<b>Application Number</b>	S/2020/2337/MAO
<b>Description</b>	Outline application with all matters reserved except access, for proposed mixed use employment site comprising of Use Class E (g) (Offices, R&D and Industrial Processes), Class B2 (General Industrial) and B8 (Storage and Distribution). To include complimentary uses and associated works.
<b>Location</b>	Podium Business Park, Shacks Barn Farm, A43 Oxford Road, Silverstone

## 1. Executive Summary

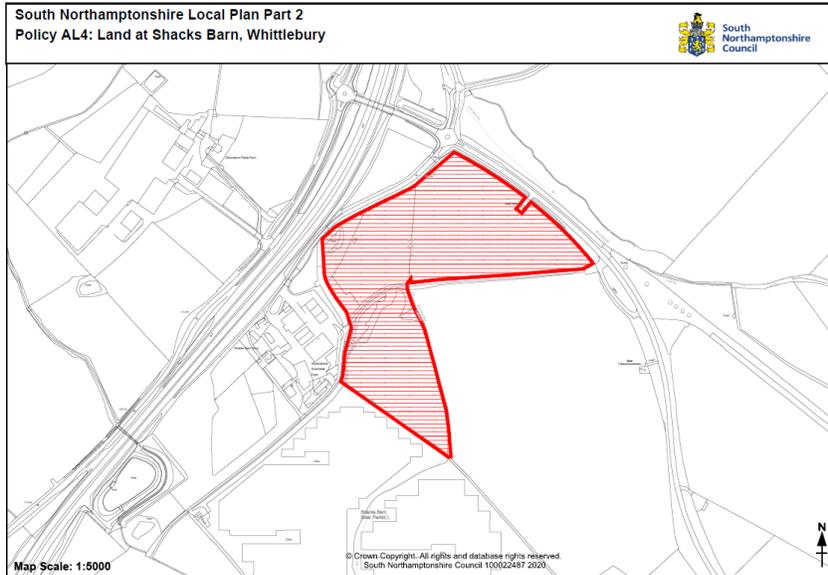
The site allocated in the Local Plan is a single site as below.

The site in the planning application drawing number 216065-PL01 includes this area, but adds a further completely separate parcel of land amounting to almost 30% of the original LP allocated area to the south west, described as attenuation and biodiversity area.

As this site lies outside the Local Plan Allocation and is completely disconnected to the original area, it is wholly unacceptable to include as part of the development. The additional land is not outlined in blue in the application and is not under the control of the applicant.

Furthermore, there are a number of inconsistencies in various documents submitted in support of the planning application. These have been overdrawn on the plan below which has been reproduced from the Plan RSE\_3385\_Pond Plan.

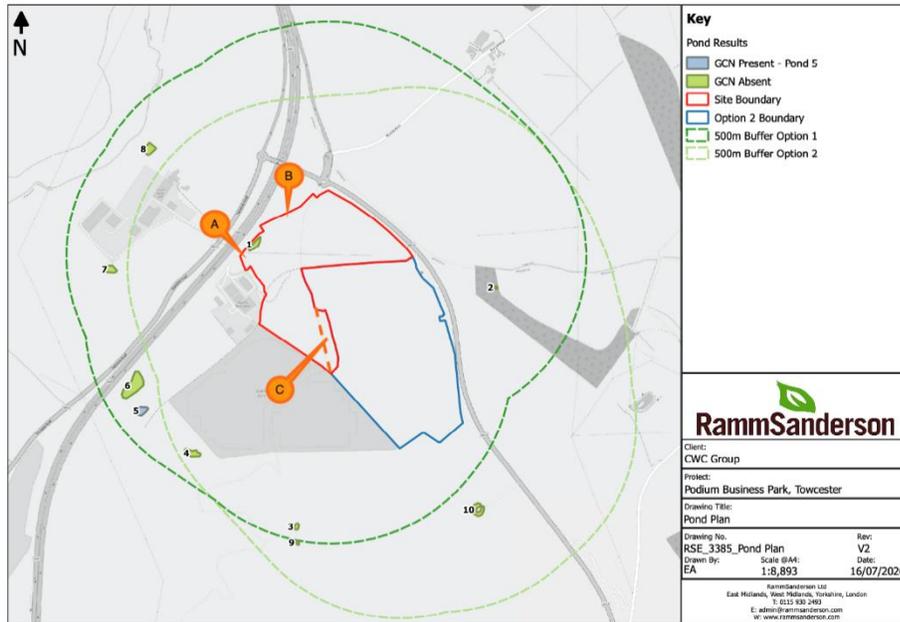
- Area (A) seems to be a small extra piece, outside the local plan outline

- Area (B) is extra thin slice, as it now includes the road (which needs widening to accommodate extra HGV traffic)
- Area (C) is an extra part that does not appear on all the submitted drawings, but is there on some of them.

- ***The scale of the proposal should be reduced so that all the required elements lie within the Local Plan Allocation Site***
- ***The inconsistencies in the submitted planning application should be rectified.***
- ***All references to extending the site must be removed from the documentation.***
